ADDENDUM TO  
BOKUM RESOURCES CORPORATION  
GROUND WATER DISCHARGE PLAN

TO THE  
NEW MEXICO ENVIRONMENTAL IMPROVEMENT DIVISION

FEBRUARY 5, 1979

Each following section is numbered to correspond to the 23 questions raised by EID. Each section is prefaced by the question raised by the EID from their October 25, 1978 correspondence.

FIGURE 10-1

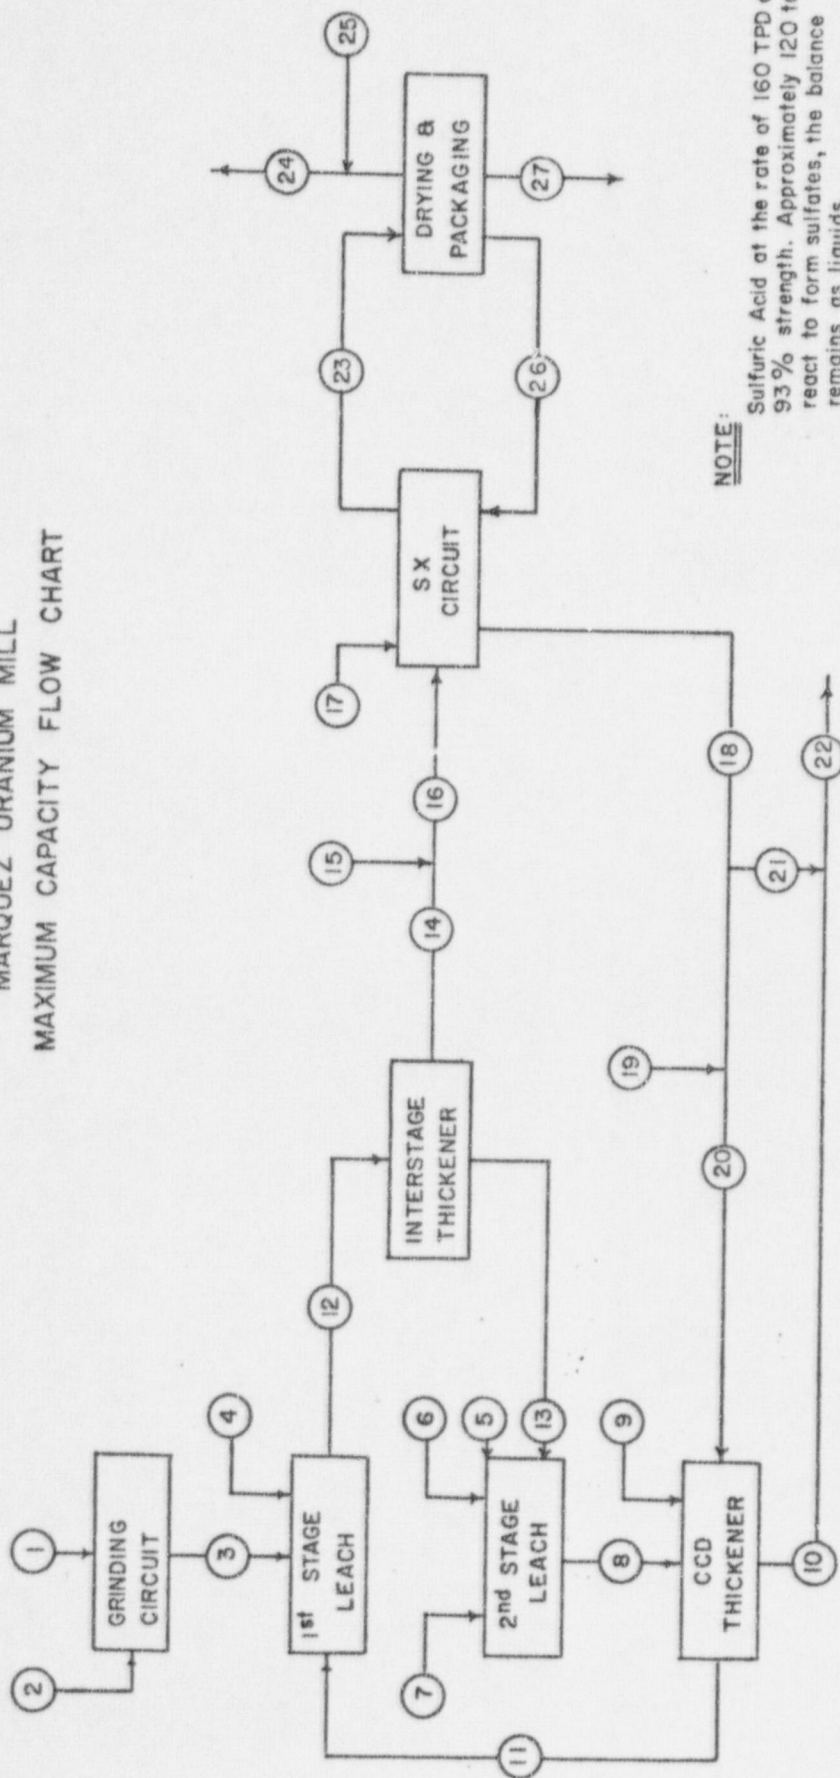
B-10: A DETAILED EXPLANATION OF THE SOURCES OF PROCESS LIQUIDS GOING TO THE TAILINGS PILE, AS WELL AS QUANTITIES TO BE RECYCLED TO THE MILL.

Figure 10-1 shows the maximum capacity mill process flow chart. Included on that flow chart are the estimated process liquids (acid, flocculant, make-up water, chemicals, etc.). Figure 10-2 shows the estimated liquids to tailing, stage capacity curve, stage time curve. From that drawing the following liquids to tailings rates are anticipated:

- 262 gpm, tailings
- 155 gpm, raffinate (85% recycle)
- 103 gpm, annual precipitation (Stages I & II)
- 132 gpm, annual precipitation (Stages III, IV and V)

FIGURE 20-1

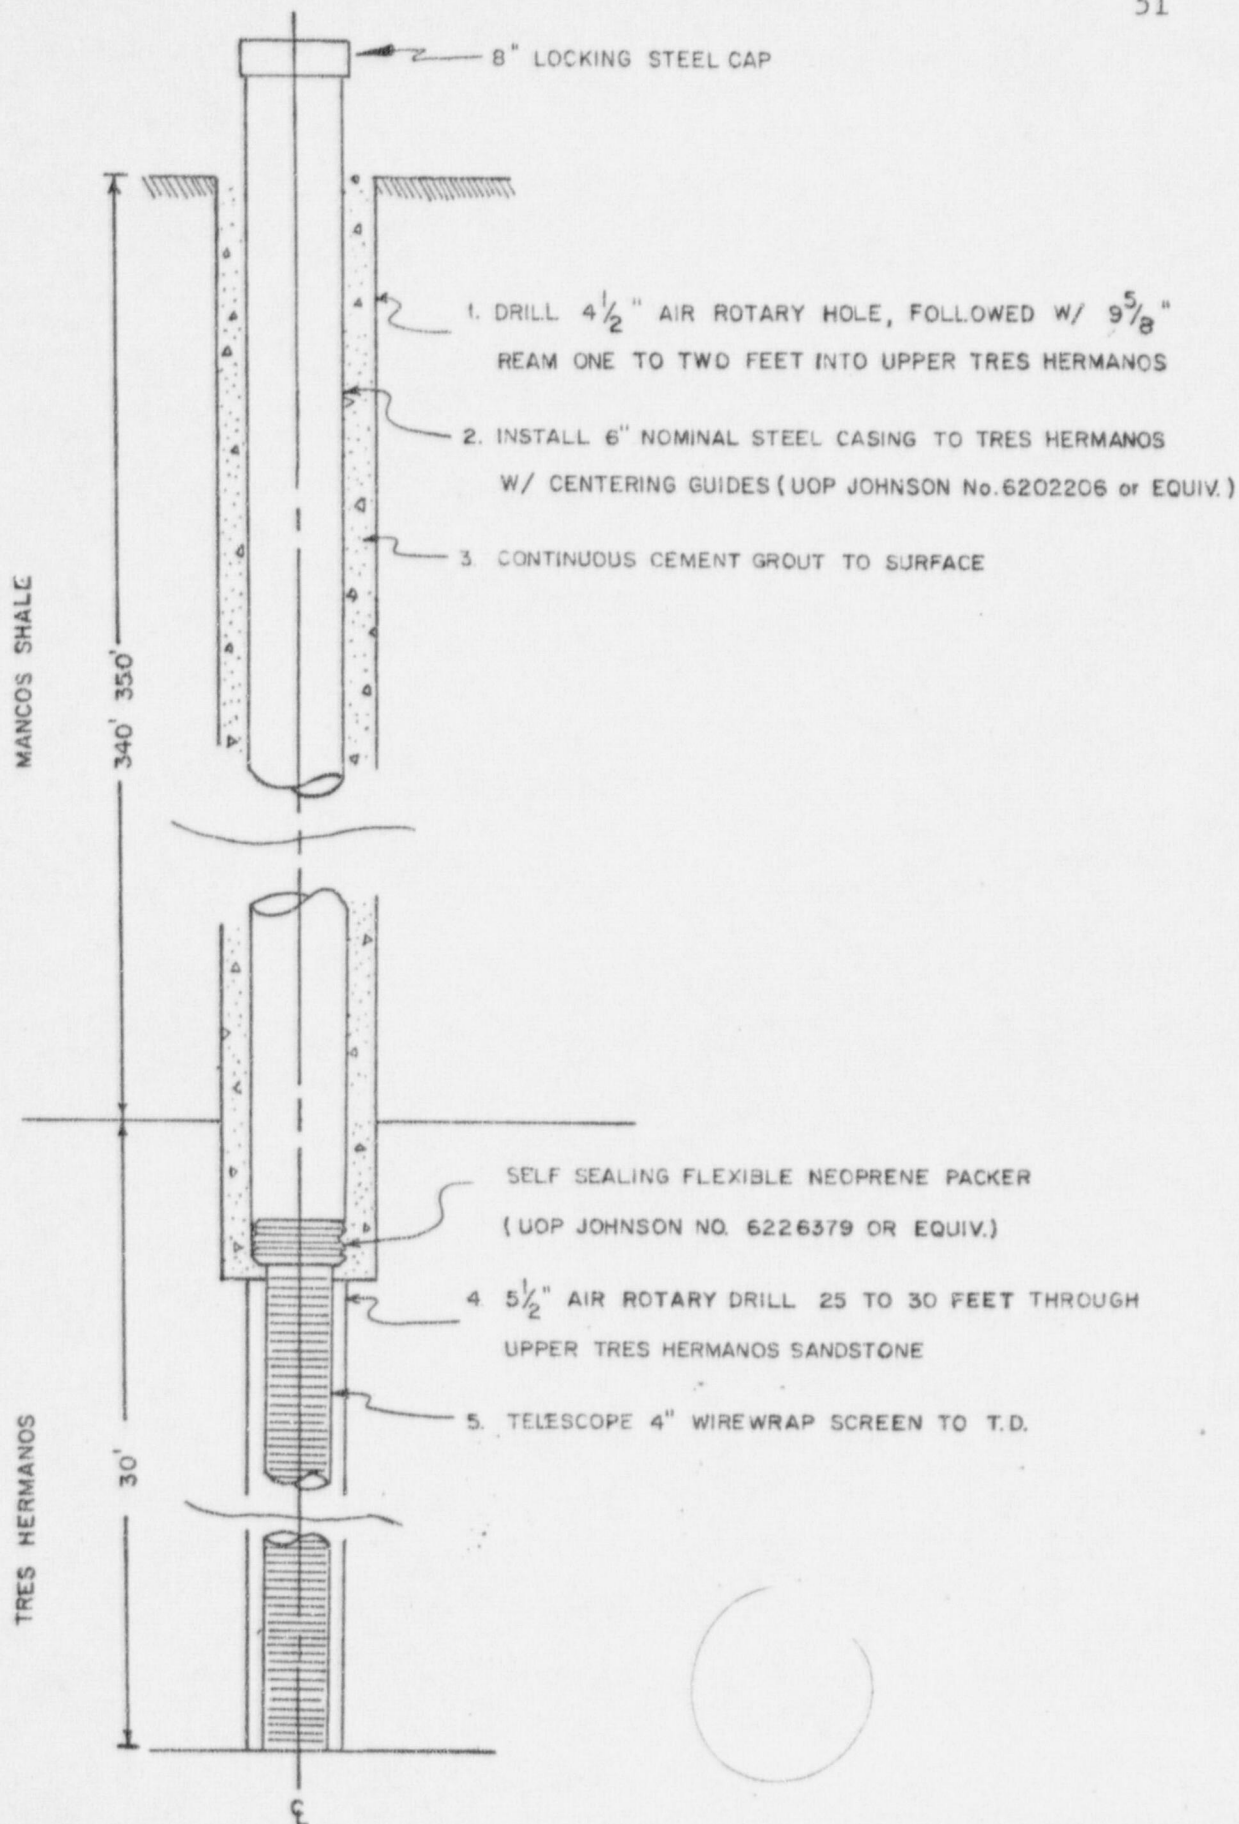
Figure 20-1 illustrates the proposed construction details for the Tres Hermanos monitoring well(s). The sequence of completion details follows:

Upon final completion, this well (TH-1) will be tested to determine if the Tres Hermanos sand is permeable enough to warrant a second well on the west side of the inferred fault. The second well will be drilled after discussion with EID and presentation of water quality and well performance data to determine if the Tres Hermanos should be further monitored. If needed, the second well would be completed in a similar manner to TH-1.

| Date | Depth | DESCRIPTION   | Sample | Recovery | Blows | Symbol | Poros. | H Perm. | NOTES |
|------|-------|---|--------|----------|-------|--------|--------|---------|-------|
|      | 5     |   |        |          |       |        |        |         |       |

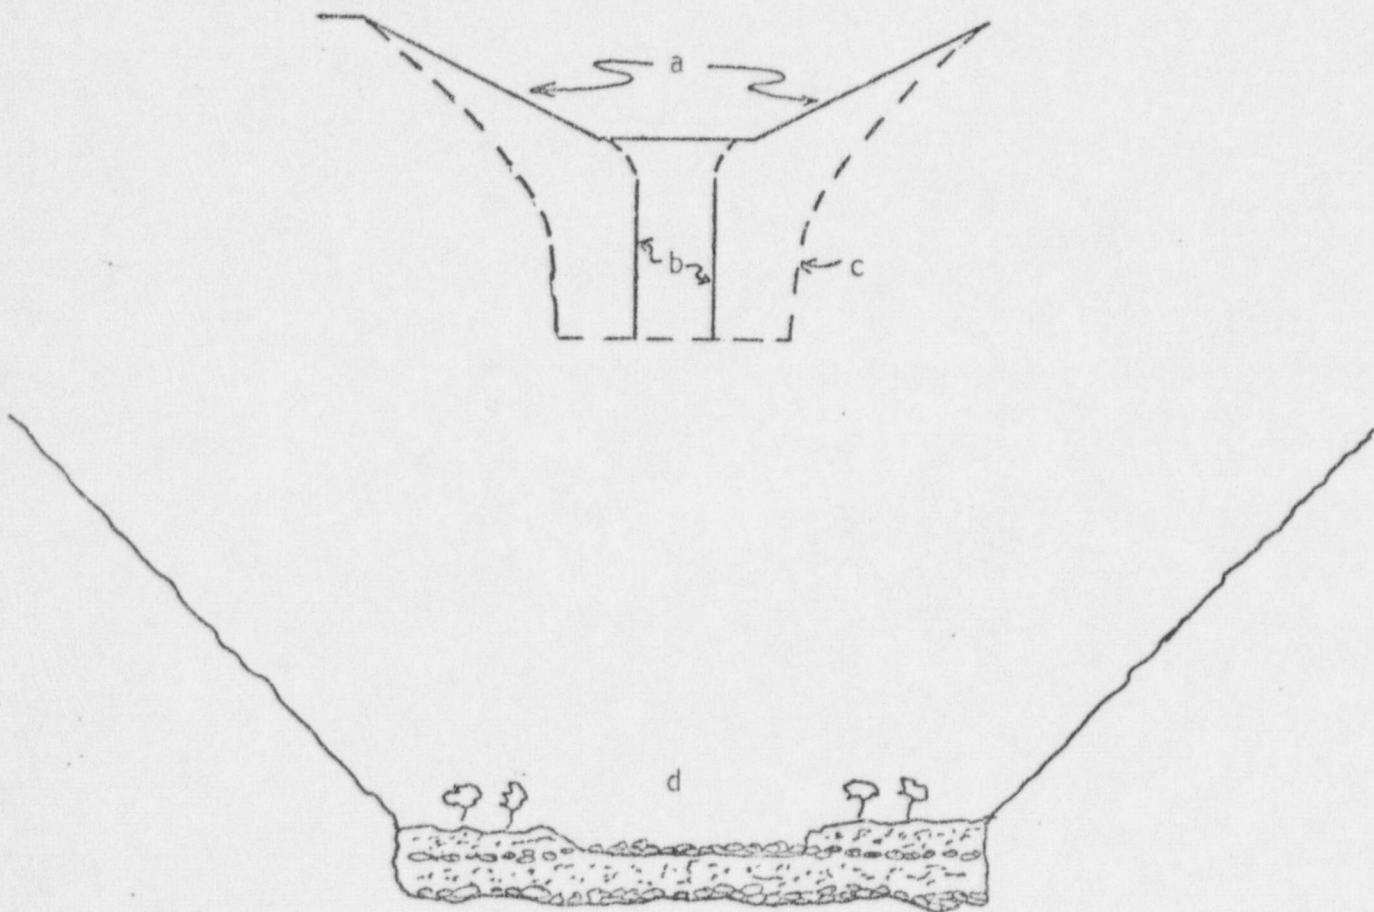
Figure 2 summarizes the evolution of an unprotected diversion channel in very general terms. If the gradient of the diversion channel will stabilize at about 2 percent over the approximately 6200 feet between the point of diversion and the junction of the unnamed tributary with the Santa Rosa channel then a maximum of about 60 feet of degradation will take place at the end of the presently designed diversion channel. The unnamed tributary is already deeply incised, and upstream from the point of maximum incision the amount of incision will decrease to zero at the point of diversion.

- a. Diversion channel as designed.
- b. Deep channel formed by vertical incision in shale bedrock during the first stage of degradation.
- c. Progressive widening of the channel by basal erosion and sheet/rill erosion will follow the initial incision. A valley will evolve.
- d. Ultimately an alluvial channel and floodplain will form on the shale valley floor and vegetation will stabilize the alluvium.

Figure 3. Generalized illustration of the projected evolution of the diversion channel with protective riprap placed on the east flank (tailings side).

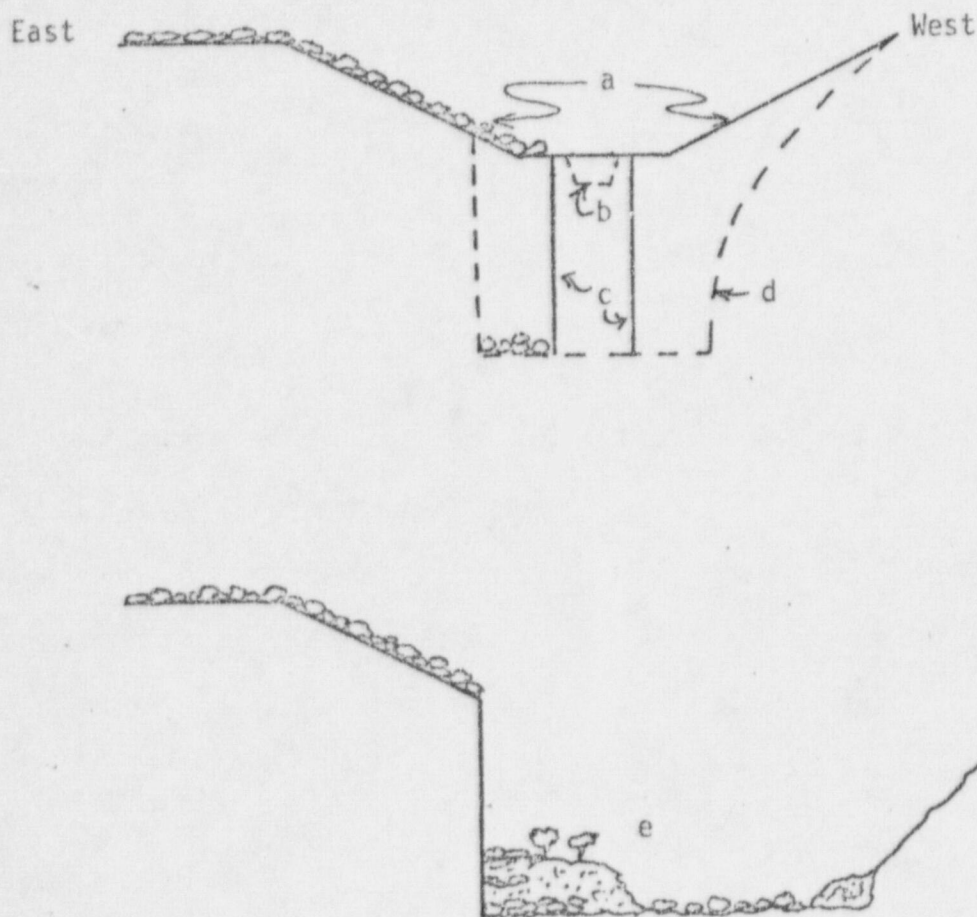
Figure 3 summarizes the evolution of a partially protected diversion channel assuming that natural degradation is allowed to occur.

- Diversion channel as designed.
- A trench at least 3 feet deep should be excavated along the center line of the channel floor to control the path of headward erosion.
- Deep channel formed in shale bedrock at the discharge end of the channel during the first stages of degradation. The depth of the incision will decrease upstream and become negligible at the point of diversion.
- Progressive widening of the channel by basal erosion and sheet/rill erosion will follow the initial incision. The riprap armor on the east flank will retard lateral erosion in an eastward direction.
- Ultimately an alluvial channel and floodplain will form on the floor of the asymmetrical bedrock valley.
